Access Compliance Report
Public Rights-of-Way
(Pedestrian Signals)

ADA ID: 0D26C0D7DBBC **Signal Type:** Two Push Buttons-Non APS **Overall Compliance:** No **Severity Score:** BTN 1: N/A BTN 2: N/A No BTN: N/A

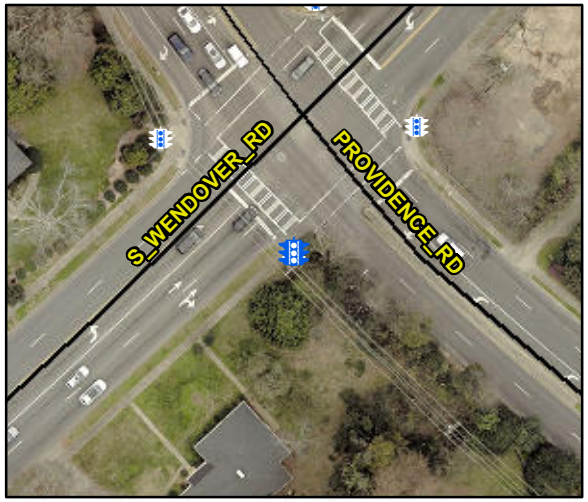
PROW/ADA: TMUTCD 4e.08, R404.2, R404.3, R406.2, R404.7.3

Possible Solutions: Replace Signal Push Button With APS Button on New Post. Remove & Relocate Sign.
